THE FAIRMONT

AN ADDITION TO WICHITA, SEDGWICK COUNTY, KANSAS

RE: SUB 2000-85 -- Final Plat of The Fairmont Addition

CASE NUMBER: SUB 2000-85 – THE FAIRMONT ADDITION

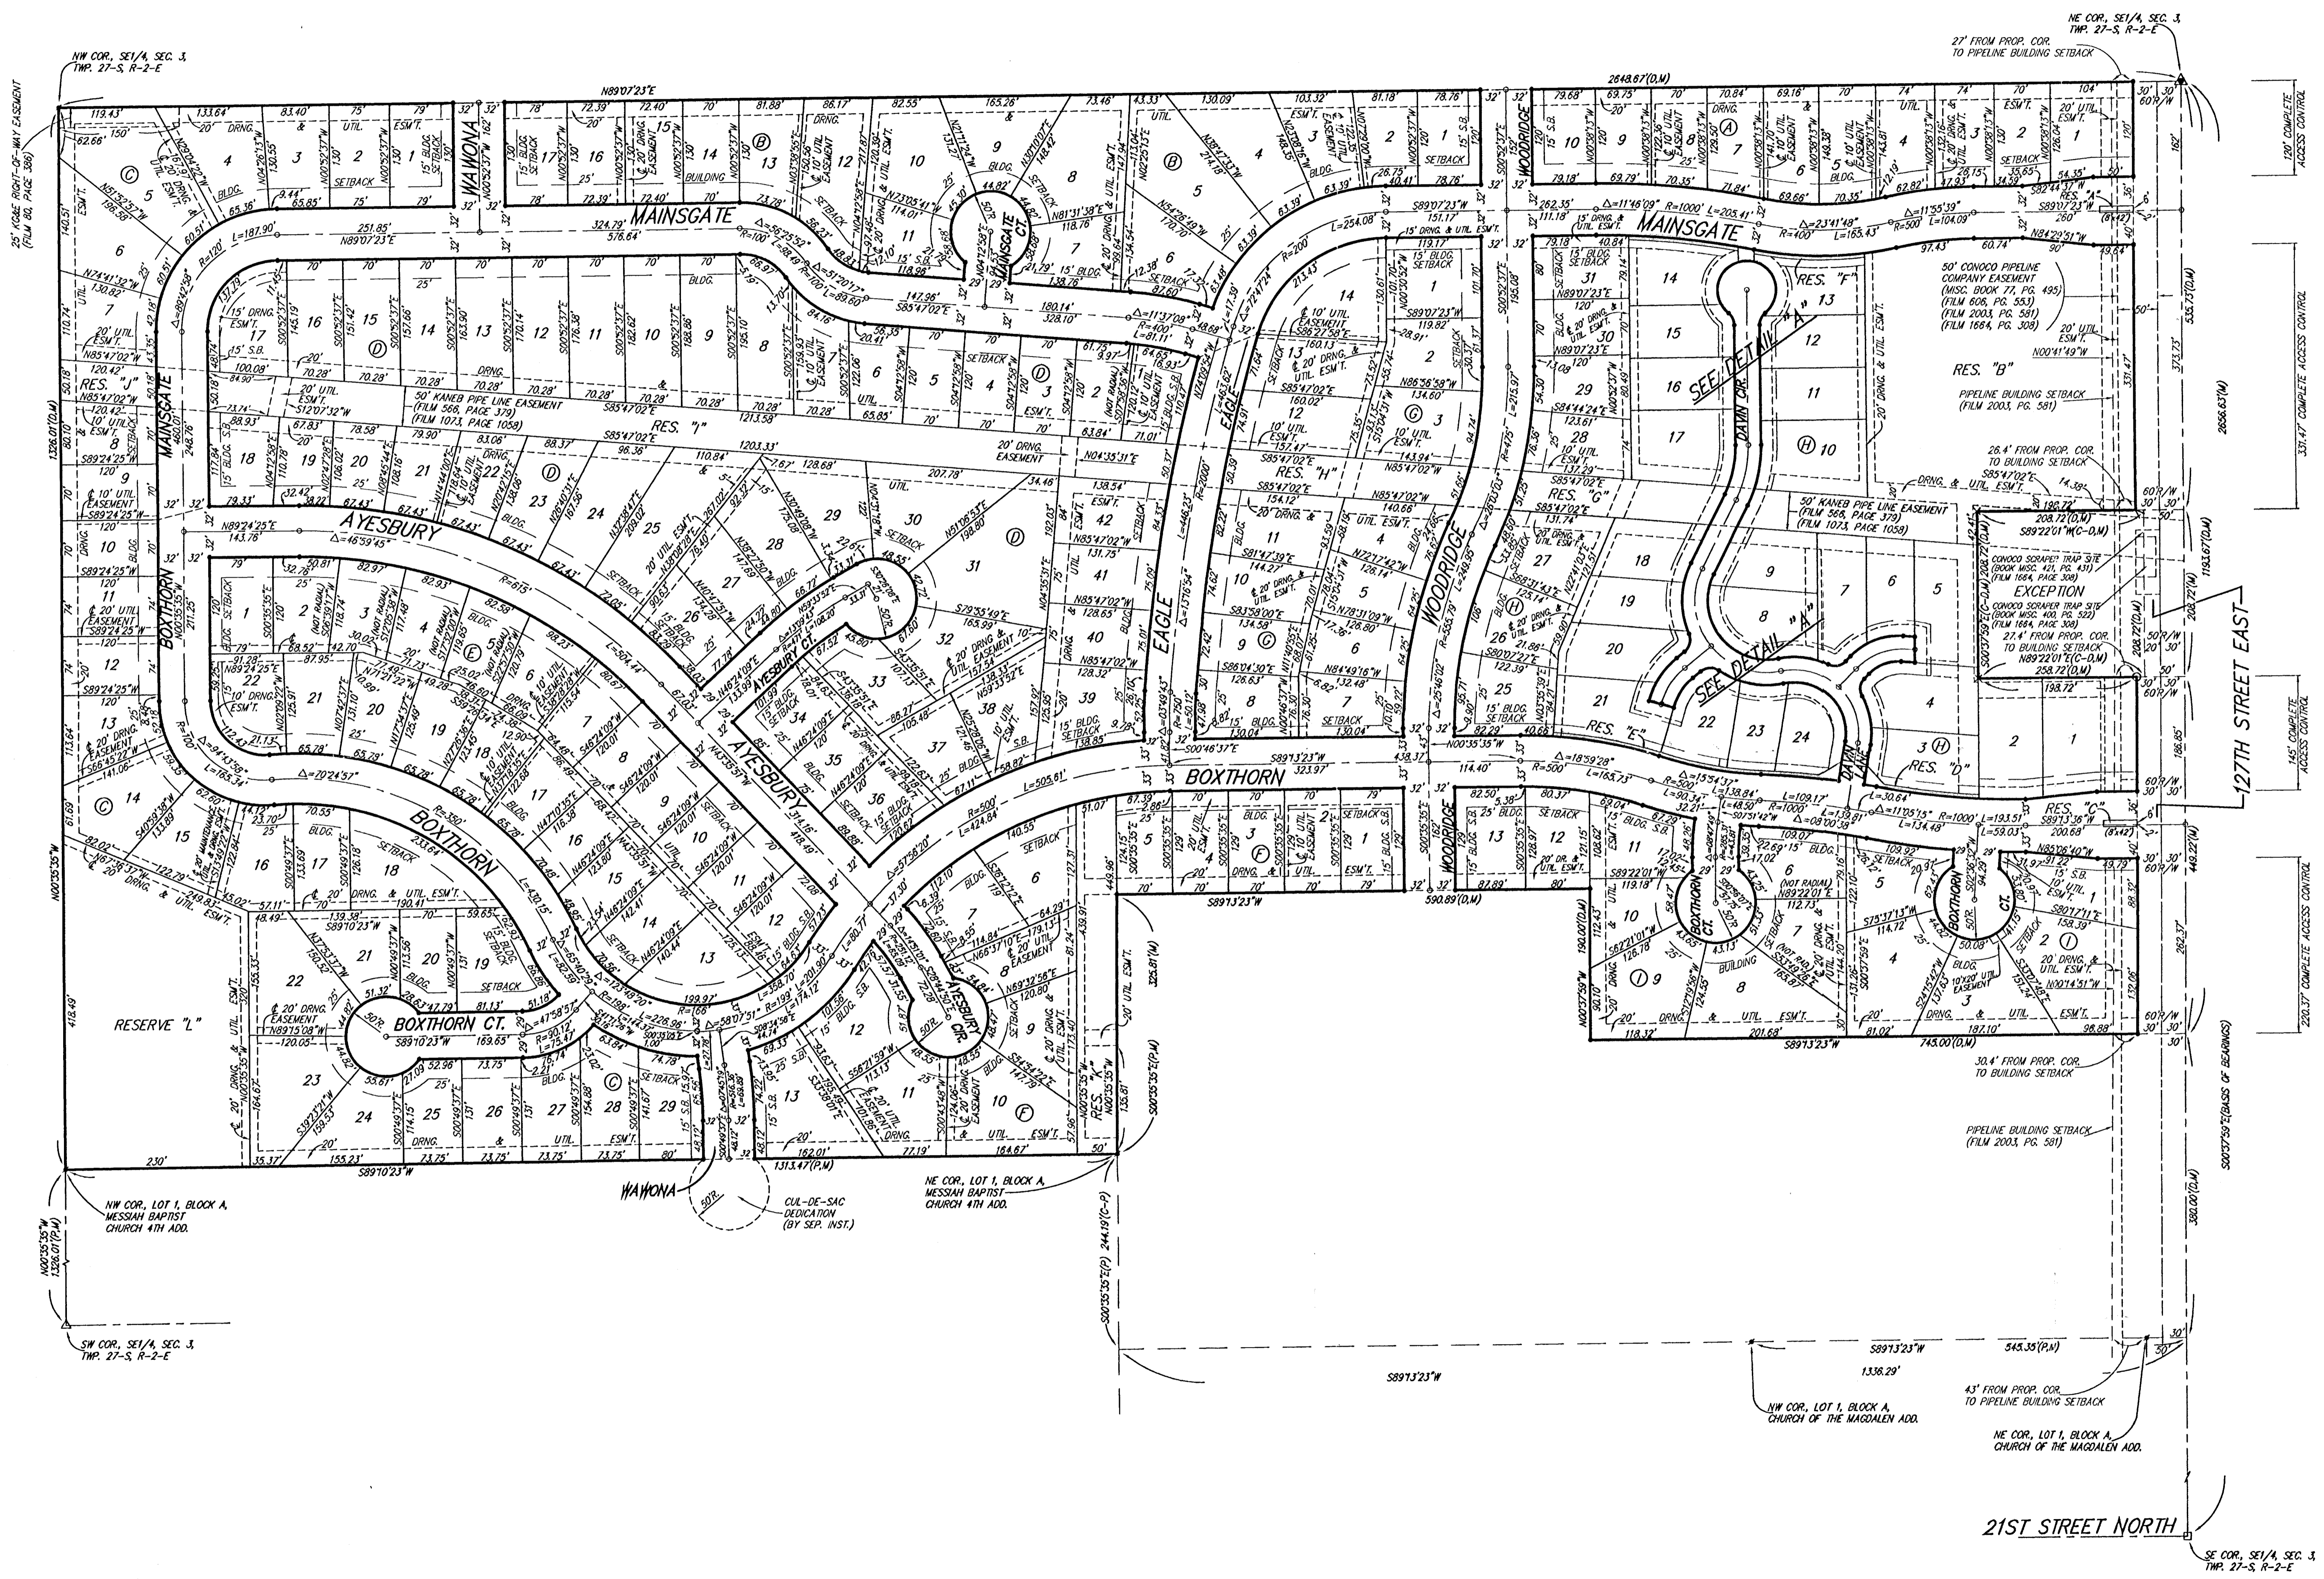
- A. The Applicant shall guarantee the extension of City water and sanitary sewer to serve the lots being platted.
- B. If improvements are guaranteed by petition, a notarized certificate listing the petitions shall be submitted to the Planning department for recording.
- C. City/County Engineering needs to comment on the status of the applicant's drainage plan. County Engineering needs a drainage plan for review. City Engineering has approved the drainage plan. A guarantee is required for improvements. Off-site drainage easements will be needed.
- D. City Fire Department/GIS needs to comment on the plat's street names. GIS has requested that the westerly stub to the south be named Wawona. Davin Ln shall be renamed Davin Cir for the segment extending beyond the second cul-de-sac. The two cul-de-sacs extending from Davin Ln should be named Davin Ct.

- E. MAPD and Traffic Engineering request the widening of Boxthorn extending from 127th St. East to the Boxthorn/Boxthorn intersection to 66 feet to conform with the collector street standards.

- J. Since this plat proposes the platting of narrow street right-of-way with adjacent "15-foot street drainage and utility easements", a restrictive covenant shall be submitted which calls out restrictions for lot-owner use of these easements. Retaining walls and change of grade shall be prohibited within these easements as well as fences, earth berms and mass plantings.

- K. Various lots in this plat exceed the maximum lot width to lot depth ratio of 2.5 to 1. **A modification has been approved by the Subdivision Committee.**

- L. **County Engineering** needs to comment on the need for improvements to 127th St. East. **County Engineering requires a petition to guarantee paving improvements to 127th St. East from the nearest paved segment to the southernmost entrance to the plat. Project estimate shall include costs for relocation of pipeline if required and parallel pipeline(s) in road right-of-way.**

The street names have been denoted as requested.

The street has been widened as requested.
- F. An off-site dedication of right-of-way is needed for a turnaround for the westerly stub street (Wawona).
- G. Centerline data is needed for the roads on Ayesbury Court and Ayesbury Circle.
